ACP File Reference: PAX 03.324270

Description: Proposed windfarm within the townlands of Tooreen, Fahanlunaghta Glendine North, Curraghodea, Silverhill, Cloghaun More, Letterkelly, Doonsallagh East, Knockalassa, Slievealoughaun and other townlands, Co. Clare.

Peer Review of Proposed Slieveacurry Wind Farm Planning Application (PAX03.324270)

Figure 28

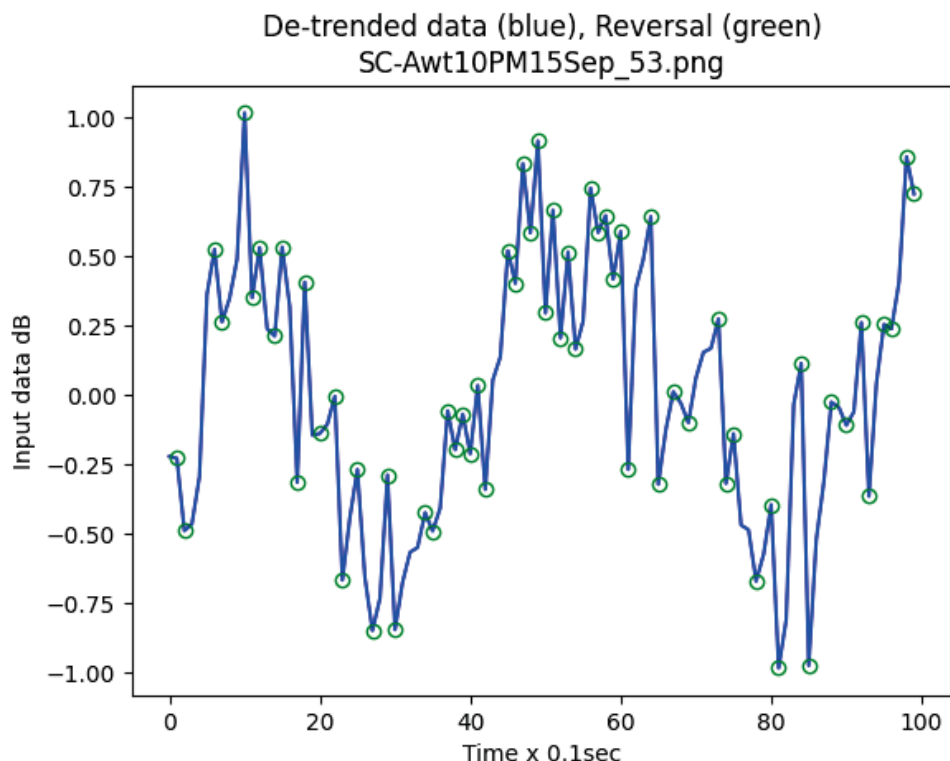
In the example of Figure 28 there are no AM values that exceed 3 dB.

An AM value is the level change between each successive reversal and the maximum AM value is shown in Figure 28 to be about 2 dB. A reversal denotes a peak or trough.

Figure 29

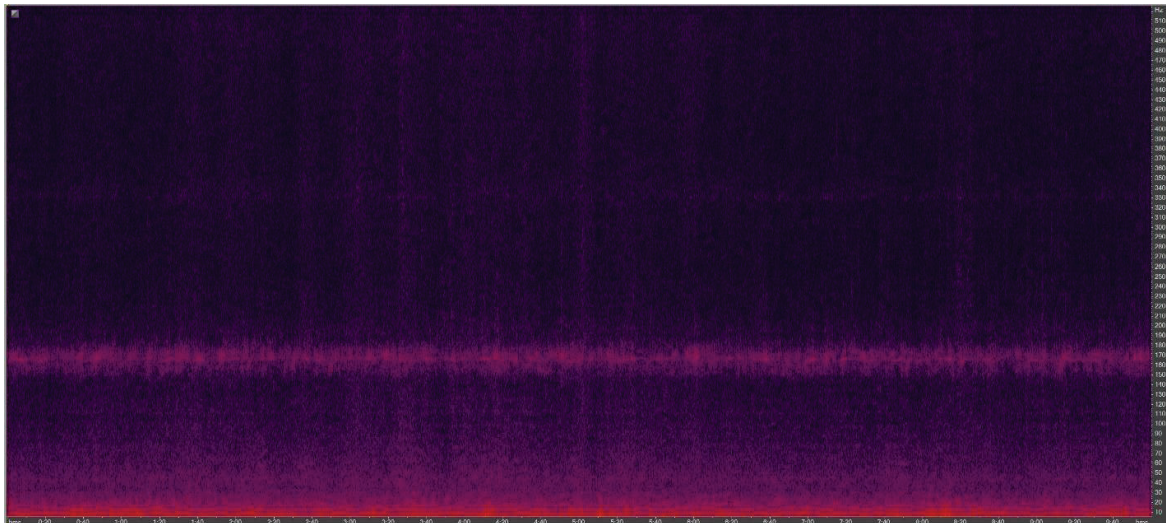
Figure 29 shows a spectrogram that illustrates the audible tone which is centred around 165 Hz.

Figure 30

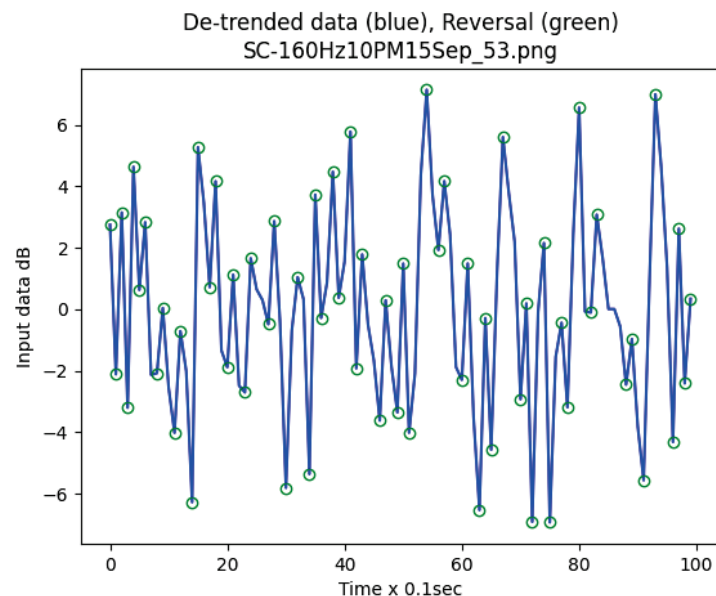
Figure 30 shows an example 10-second sample of the variation in sound level of the 160 Hz 1/3 octave band.

AM of the 160Hz 1/3 octave band regularly exceeds 10 dB peak to trough.

Figure 29

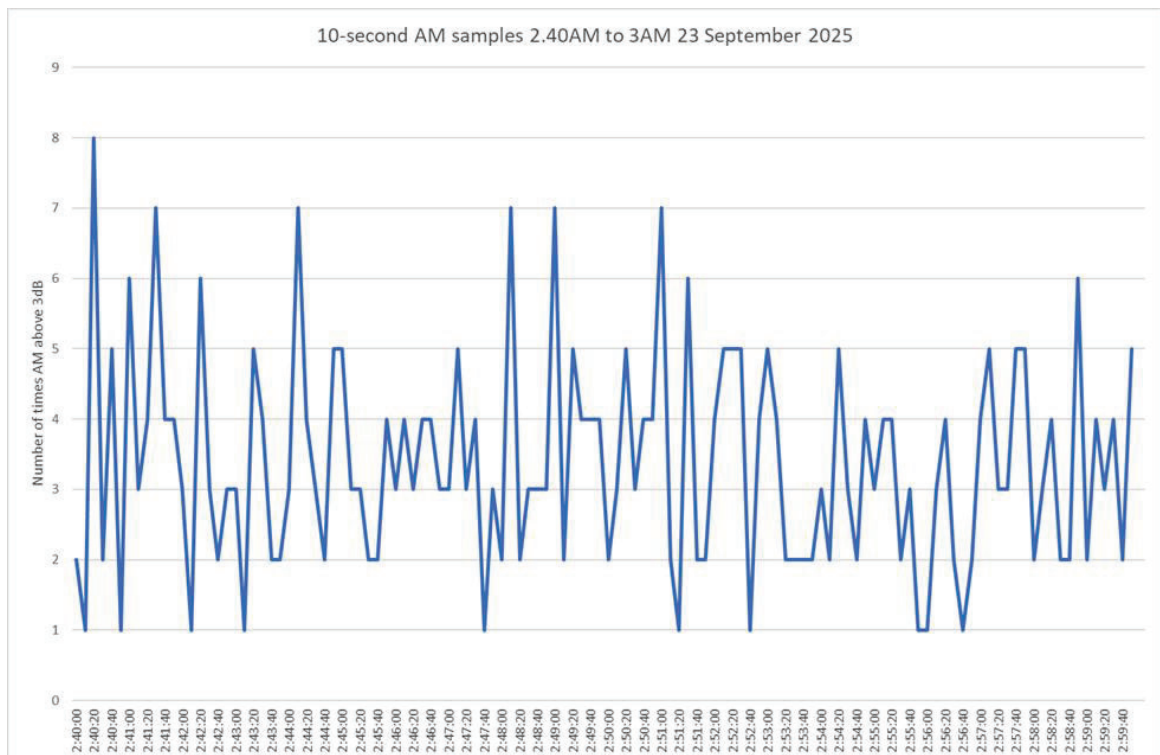
Figure 29 shows the number of times that A-weighted AM, caused by the swish sound from many wind turbines in the morning (2.40 am to 3 am) of 23 September 2025, exceed 3 dB when measurements were less influenced by extraneous noise.

The number of times that an AM value has exceeded 3 dB does not indicate the level of those exceedances. For example; occasions of a 'whump' or 'thump' type sound common to wind turbines that present as intermittent high levels of AM cannot be gleaned from Figure 29 but the regularity of AM values higher than 3 dB is evident.

Figure 30

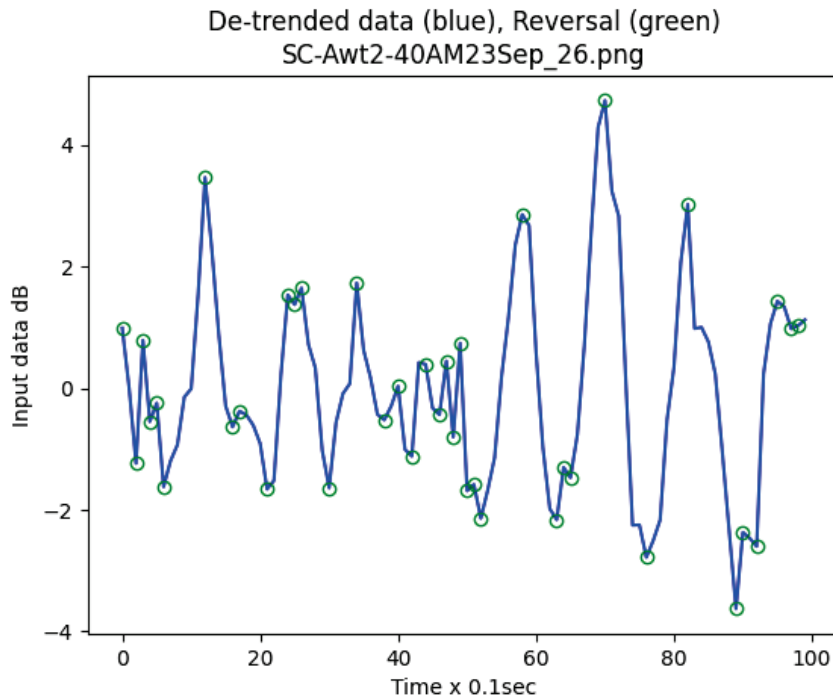
Figure 30 shows an example 10-second A-weighted AM sample where there are AM values greater than 6 dB that warrant the application of a penalty.

Figure 31

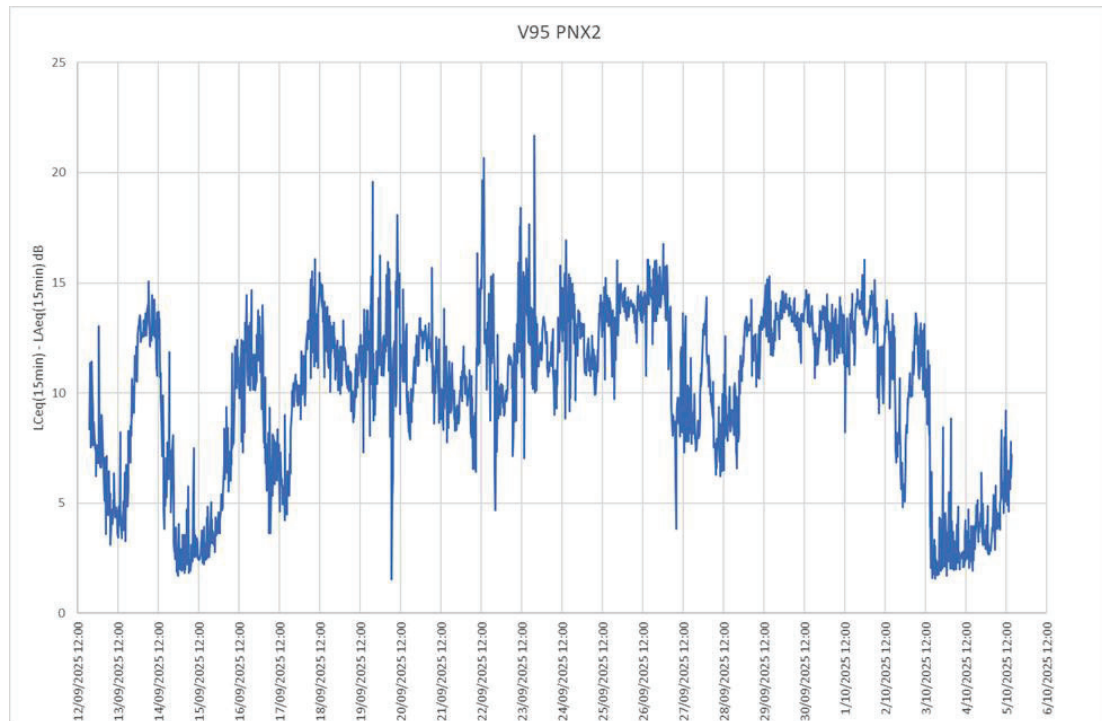
A difference of $L_{Ceq,10min}$ minus $L_{Aeq,10min}$ greater than 15 dB indicates significant LFN presence and Figure 31 presents the differences obtained during the survey period.

The difference between L_{Ceq} and L_{Aeq} can be influenced by extraneous noise from wind in trees that may indicate a false negative (indicating no LFN when there is strong LFN).

Figure 32

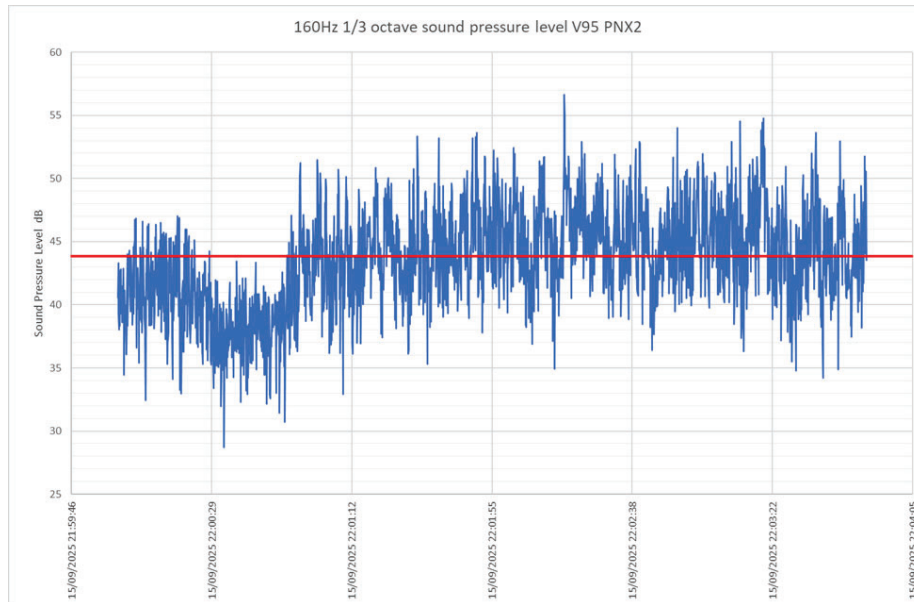
Figure 32 shows that the 160 Hz third-octave regularly exceeded 44 dB (red line) in the evening of 15 September 2025 and this indicates that low frequency annoyance is to be expected.

Figure 1 Location of wind turbines (T) and some NSLs

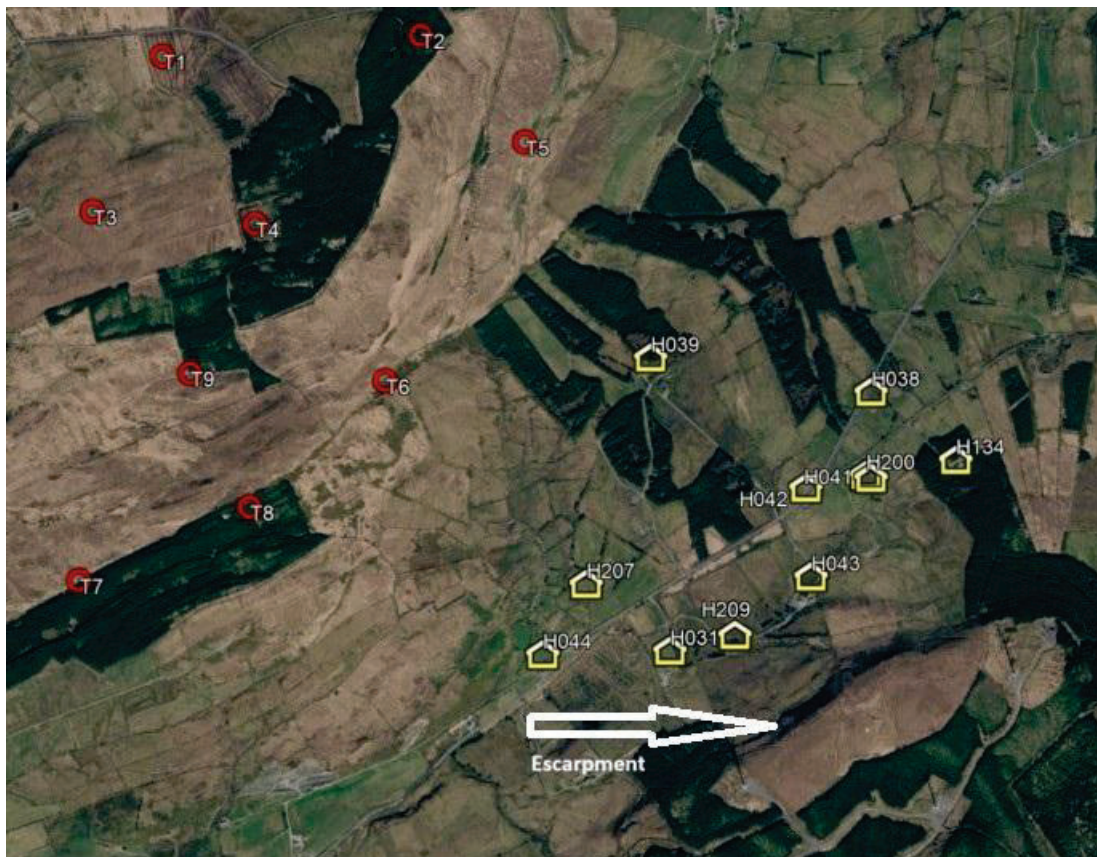
- An escarpment to the south east of the proposed development has the potential to increase noise levels through reflection for dwellings between it and the proposed Slieveacurry Wind Farm that are shown in Figure 1.

A 50 m high escarpment shown in Figure 1 can enhance sound levels through reflection for the NSLs shown.
